Access Compliance Report

Public Rights-of-Way

Intersection ID: 46470	Main Street: CRANDON_DR	Cross Street: PEACH_BUD_LN	Location: SW
ADA ID: 5B1015490060	Ramp Type: PerpDiag	Initial Pass/Fail: Fail	Overall Compliance: No
		Severity Score: 15

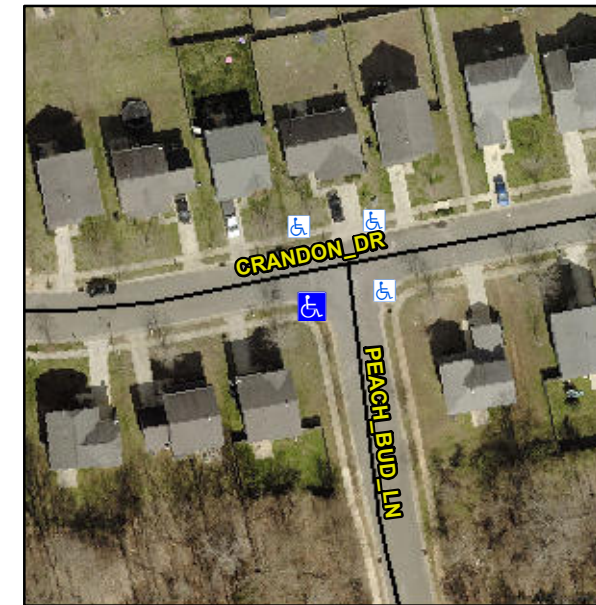
Not Found, R302.7

N/A	Ramp inside XWalk1?	N/A	N/A	Ramp inside XWalk2?	N/A
	Road Slope (%)	3.0	N/A	Clear Space?	N/A
	Road X Slope (%)	4.7	N/A	Clear Space to XWalk (in)	N/A
N/A	Any Obstructions?	N/A	N/A	Storm Grate/Utility Hazard?	N/A
	Obstruction Type			Storm Grate/Utility Type	
		N/A			N/A
		No		Surface Condition? (G/P)	Poor

Remove & Replace Curb Ramp With Two New Directional Ramps or Equivalent.
